DATE: 2023-06-09

MODEL: SR3/SR10

STEERING COLUMN TUBE**PRIORITY – HIGH (ACTION)**

Steering column SC0056. The new parts can be identified by having a physical batch plate now positioned on the lower portion of the shaft, see below:

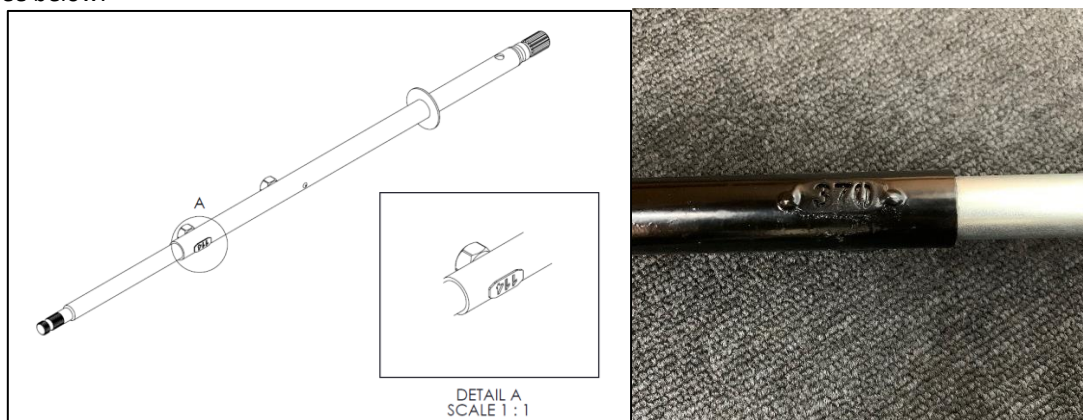
Following 2 unexpected issues Radical has investigated a batch of steering columns fitted to older SR3 and SR8 cars. Small manufacturing tolerance issues were found. Out of an abundance of caution Radical suggests to replace the part. The part has not been used on production cars since 2021.

- 1 – centre the steering position
 - 2 – remove steering wheel, remove lower end of steering column from universal joint
 - 3 – replace steering column and reattach universal joint being sure to check steering is still straight
- Approximate time required 20mins
